# WATER DISTRIBUTION SYSTEM IMPROVEMENTS TO SERVE A PORTION OF LOT 1, BLOCK 1 MACWEST ADDITION CITY OF WICHITA, KANSAS

GARY JANZEN, P.E. CITY ENGINEER  
PROJECT NUMBER  
2219 PPW (183021)

**AS BUILTS**

**WATER PLAN & PROFILE**

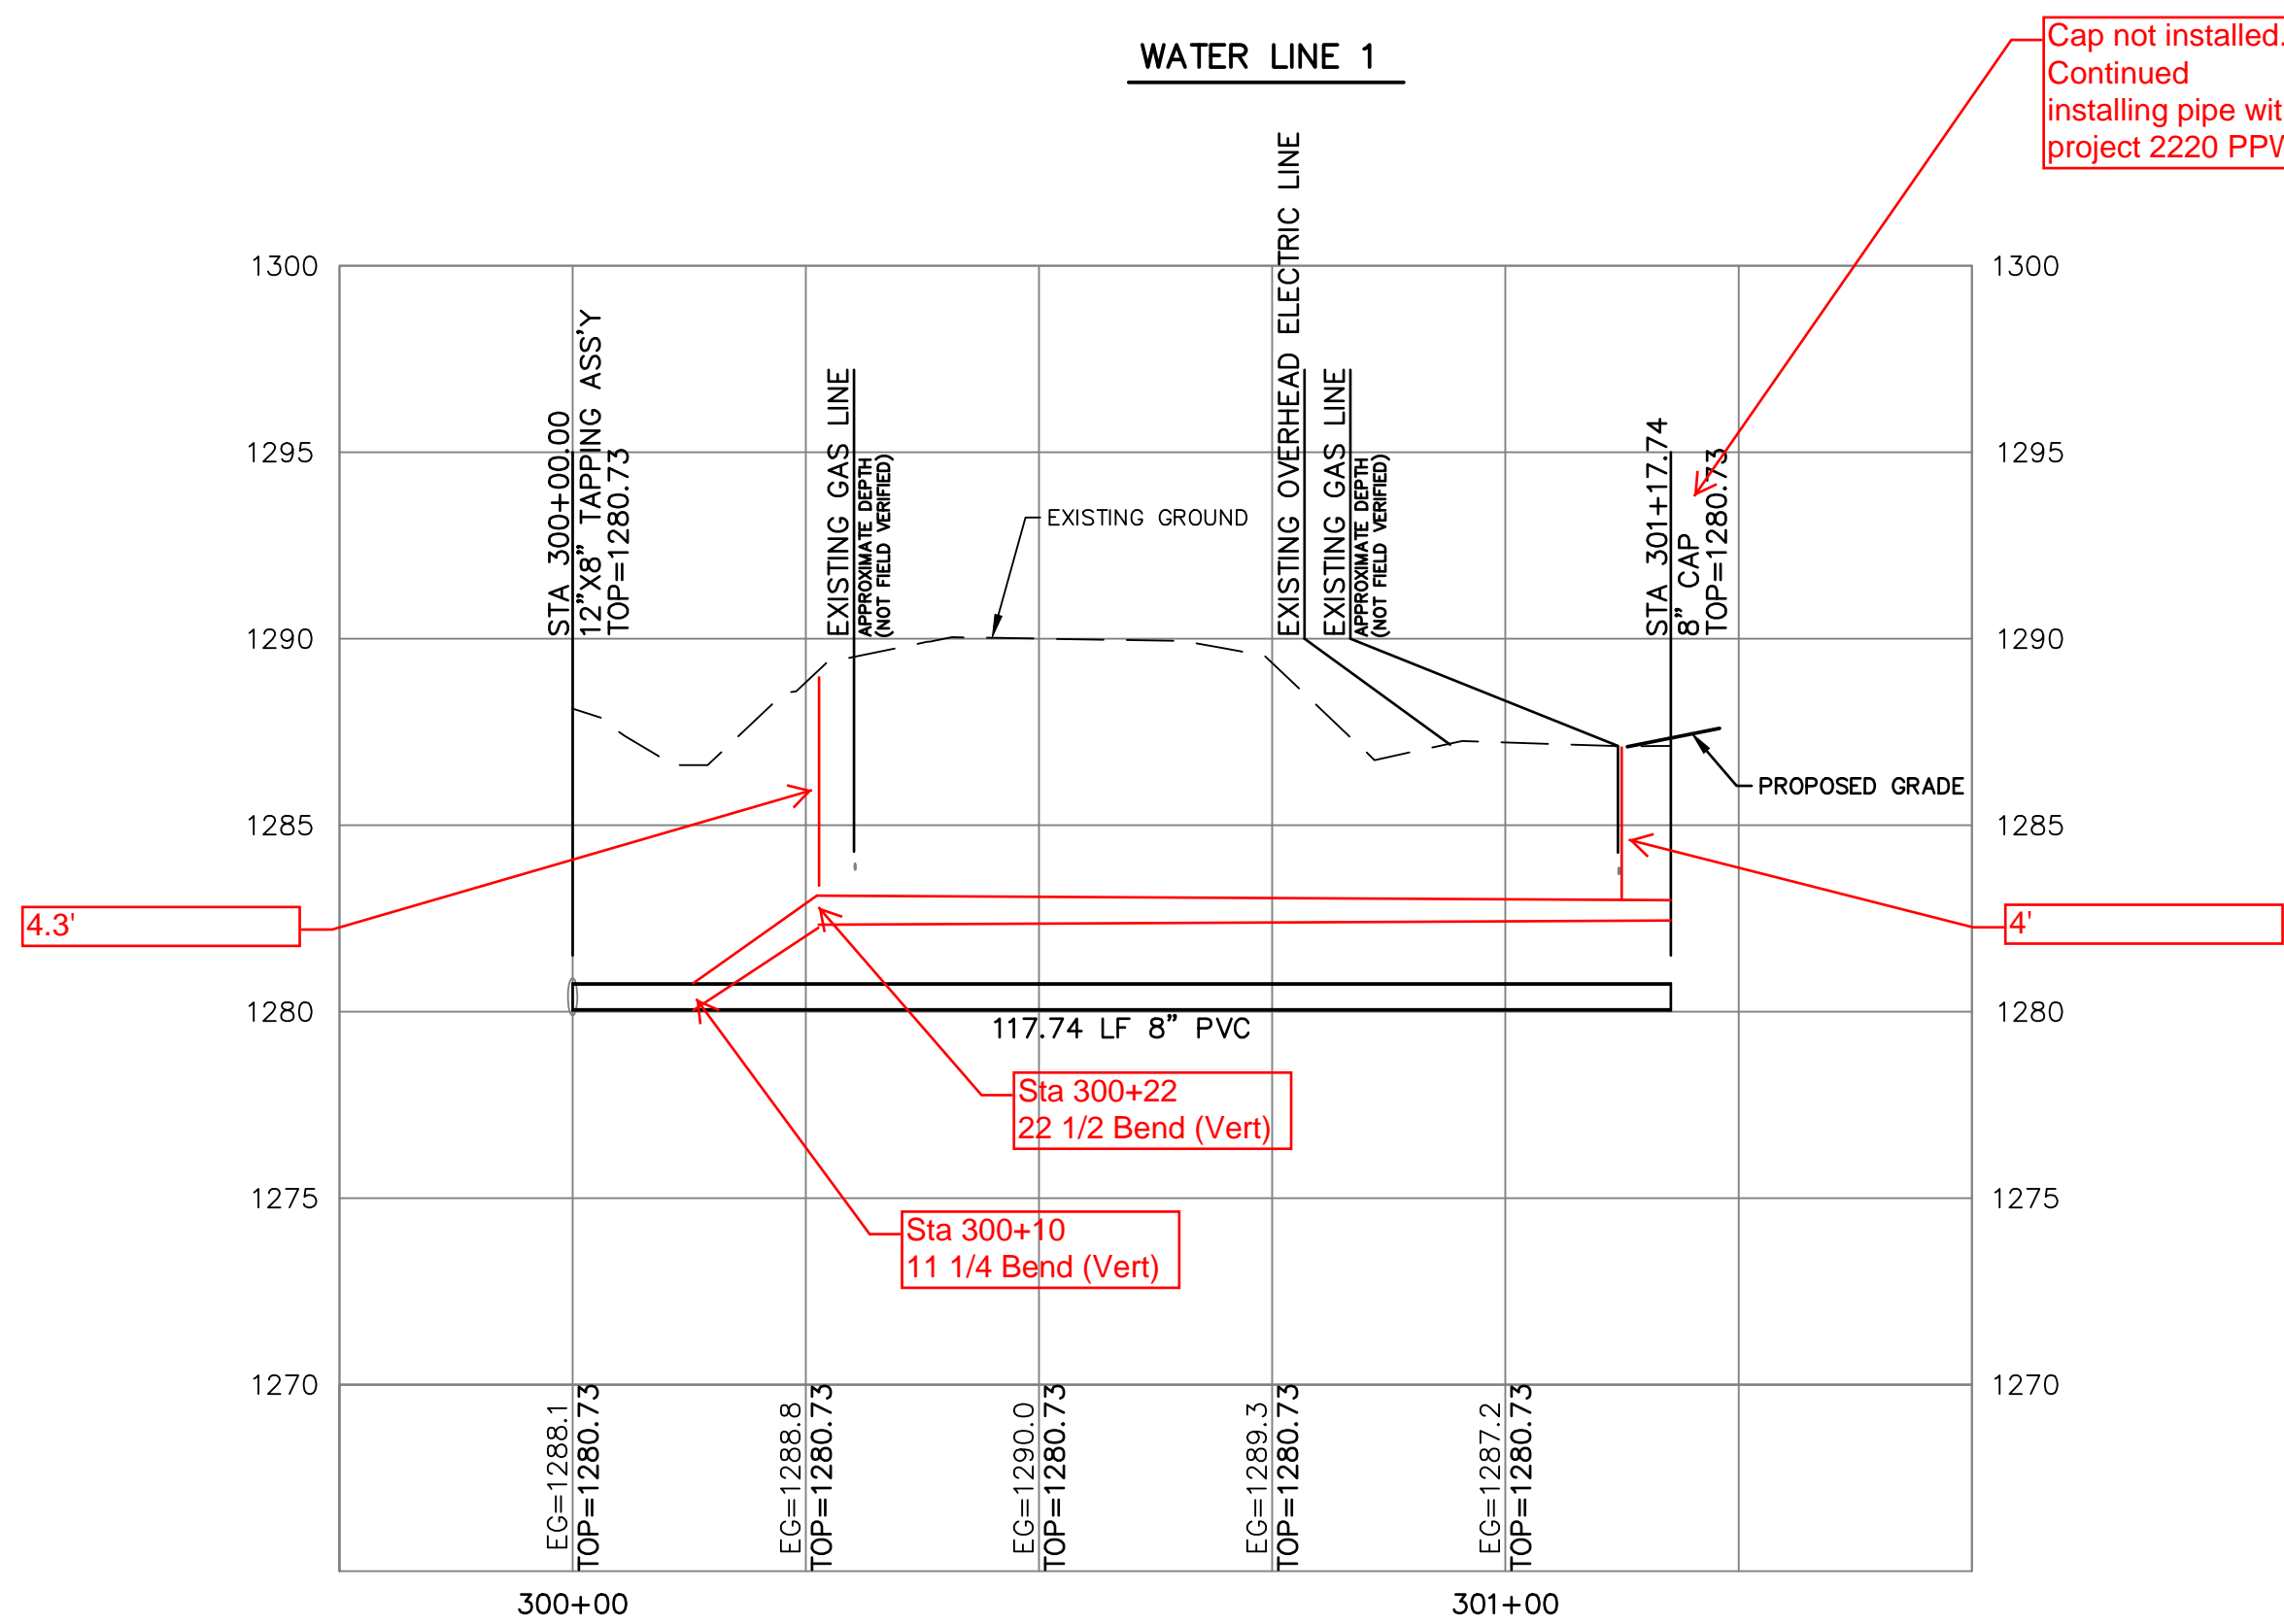
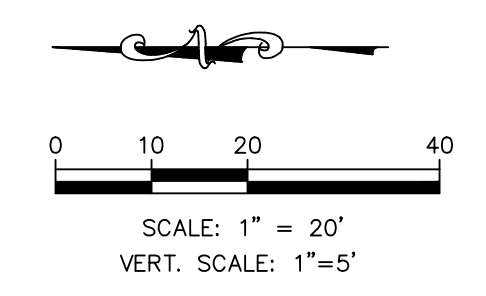
Sta. 300+10  
11 1/4 Bend (Vert)  
818' W & 40' N of  
the CL intersection  
of MacArthur &  
West.

Sta. 300+22  
22 1/2 Bend (Vert)  
818' W & 28' N of  
the CL intersection  
of MacArthur &  
West.

Cap not installed.  
Continued  
installing pipe with  
project 2220 PPW.

STA 301+17.74 - WATER LINE 1  
1-8" CAP  
N 1662346.20, E 1633471.70

Cap not installed.  
Continued  
installing pipe with  
project 2220 PPW.

Sta 300+22  
22 1/2 Bend (Vert)

Sta 300+10  
11 1/4 Bend (Vert)
